### **AMENDMENTS TO THE DRAWINGS**

**REMARKS**

*Fig. 8*

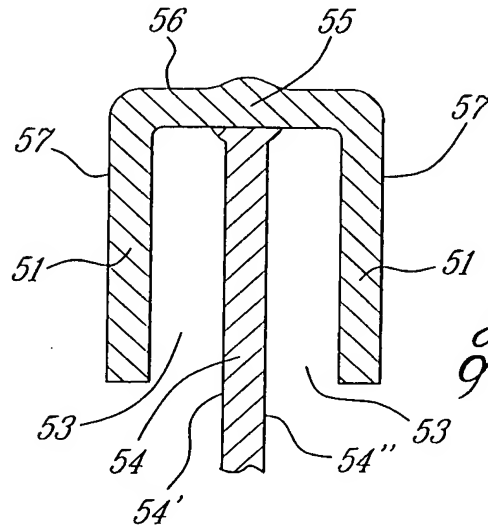
The attached sheets of drawings include changes to Figures 8 and 12. These sheets replace the original sheets. These amendments are being made to clarify the drawings to be more consistent with the disclosure in the specification.

In the Office Action the Examiner questioned the construction of the display frame and particularly its integration into the wire mesh walls of the shopping cart. Figures 8 and 12 have been modified to remove some ambiguity which led to this questioning.
